UNITED STATES PATENT AND TRADEMARK OFFICE

Office Action Summary

10/821,860

DETAILED ACTION

Fig. 12

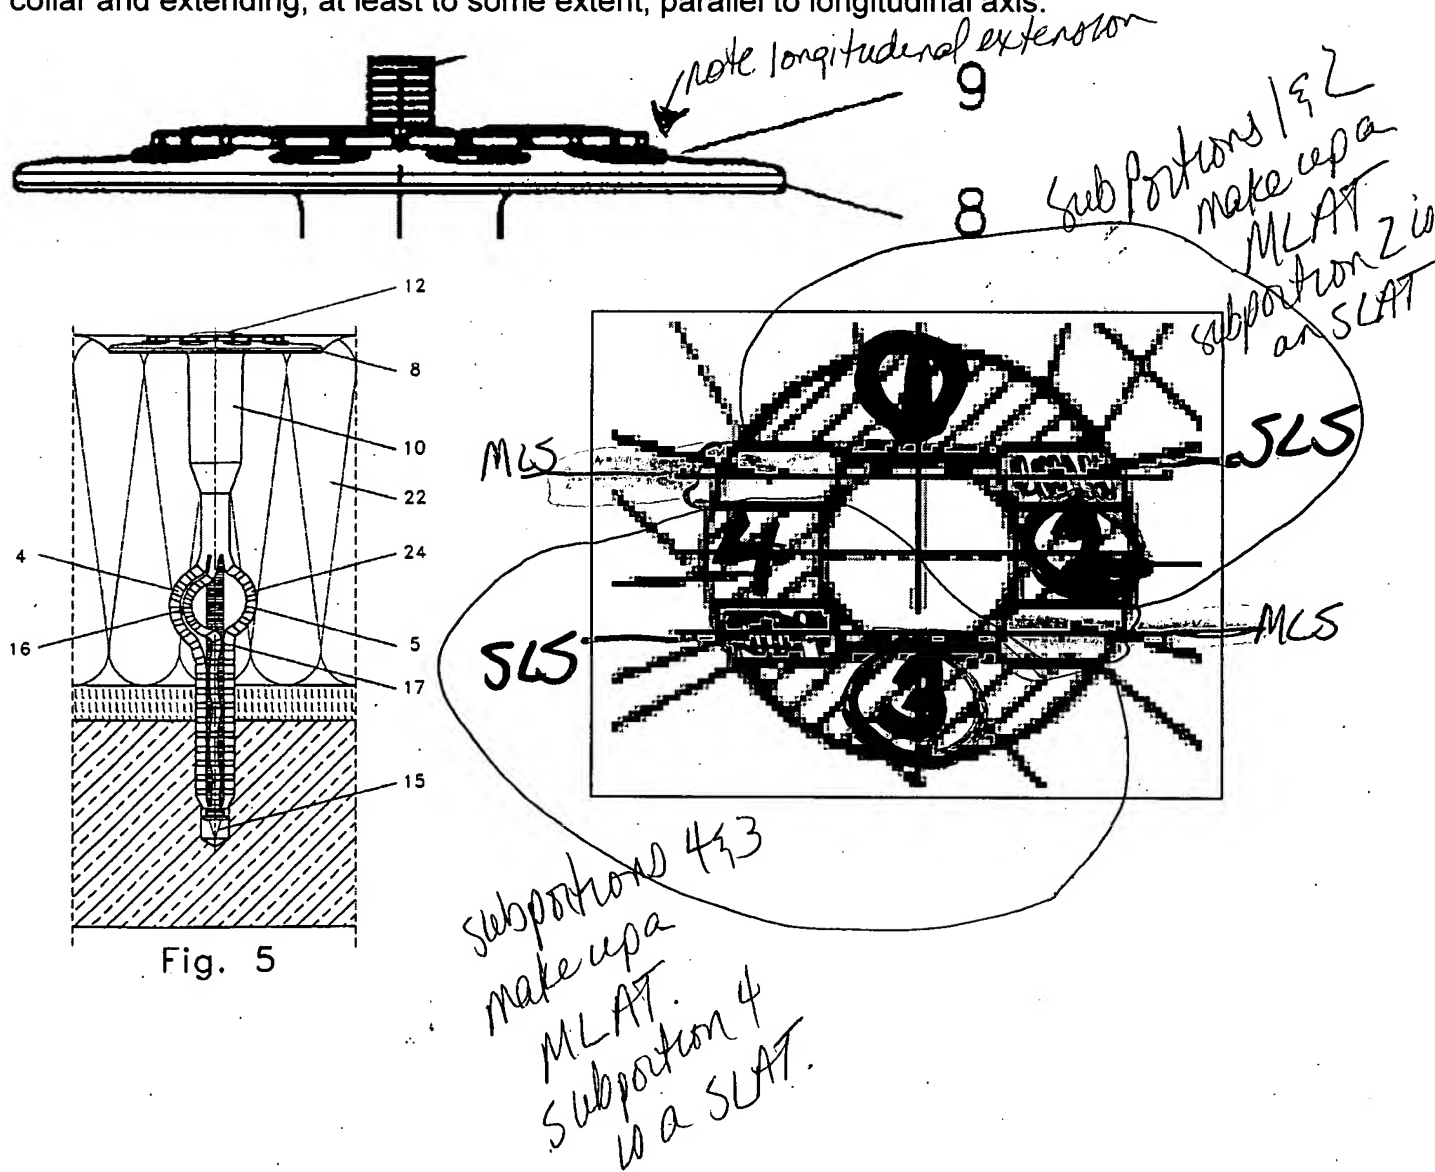
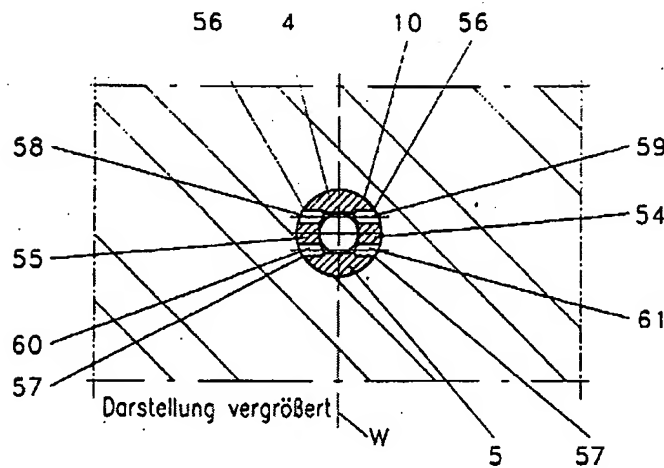
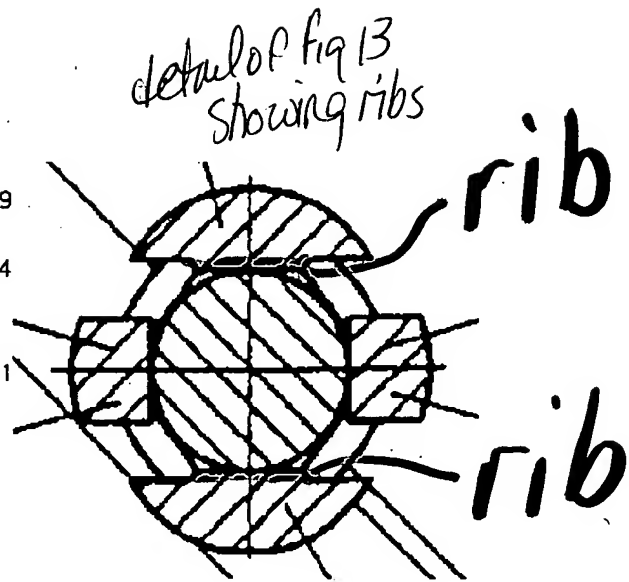
Re claim 11: Fig 1 (detail below) shows projecting appendices 9 integral with collar and extending, at least to some extent, parallel to longitudinal axis.

Re 12: Portion at end near "15" in Fig 5 is considered a head at 2nd end.

Re 13: There is a coaxial through hole. There are internal longitudinal ribs (see detail of cross sectional cut, ^{Fig 13} above, extending into hole.

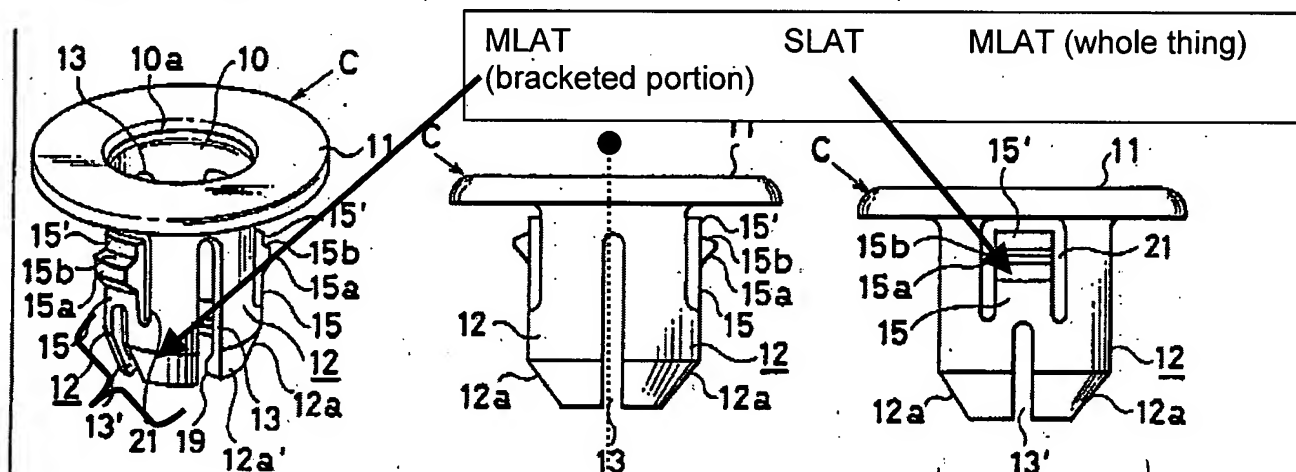
- 106 teaches a screw anchor comprising main longitudinal tongues (entire side shown in Fig 4)

axis/plane
into/out of page

this is one MLAT.
A SLAT is formed
by SL5 "21"

As Fig 3 (middle figure above) shows, the MLATs are diametrically opposite each other with respect to a longitudinal axis of the anchor. SLATs are arranged in pairs (1 SLAT forms a pair with the other SLAT to form a pair of diametrically opposed SLATs, and each respective SLAT is arranged with (surrounded by) the respective MLAT that surrounds it to form a pair of tongues on the same side of the axis. Each SLAT is shorter than and narrower in width than each MLAT.

Re 15: MLATs are separated by MLS (13 (not 13')) which extend essentially parallel to a plane on which the screw anchor longitudinal axis lies, and the MLATs lie on opposite sides of the plane (Plane drawn by examiner on Fig 3 above is a plane going into and coming out of the page, and this plane includes anchor longitudinal axis)

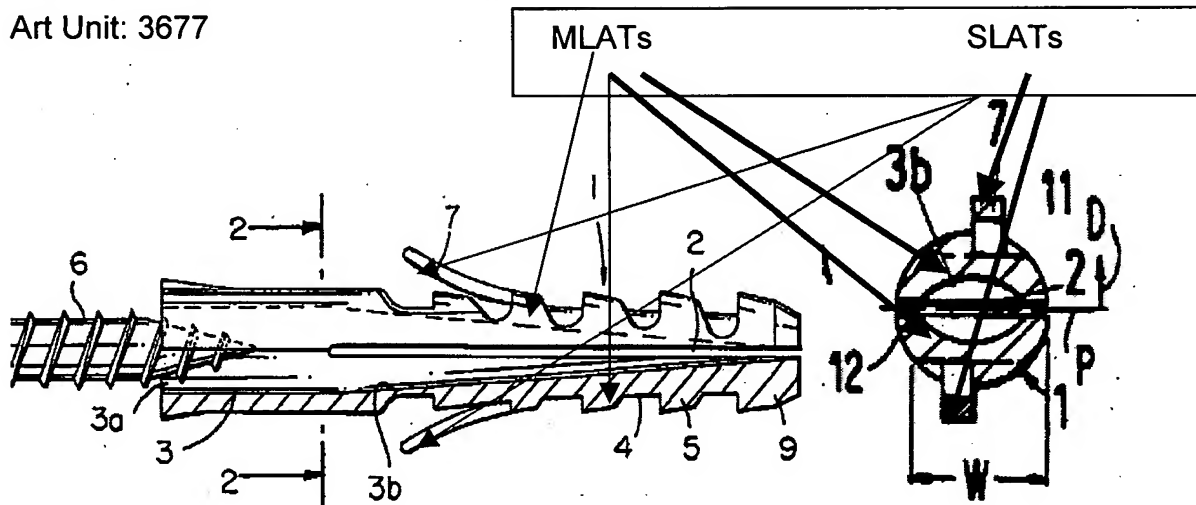
- Fischer teaches a screw anchor comprising main longitudinal tongues (MLATs) with the MLATs are diametrically opposite each other with respect to a longitudinal axis of the anchor. (MLATs are each the two halves formed by longitudinal slot 2) SLATs 7 are arranged in pairs (1 SLAT forms a pair with the other SLAT to form a pair of opposed SLATs, and each respective SLAT is arranged with (surrounded by) the respective MLAT that surrounds it to form a pair of tongues on the same side of the axis. Each SLAT is shorter than and narrower in width than each MLAT.

Re 15: MLATs are separated by MLS (2) which extend essentially parallel to a plane on which the screw anchor longitudinal axis lies, and the MLATs lie on opposite sides of the plane
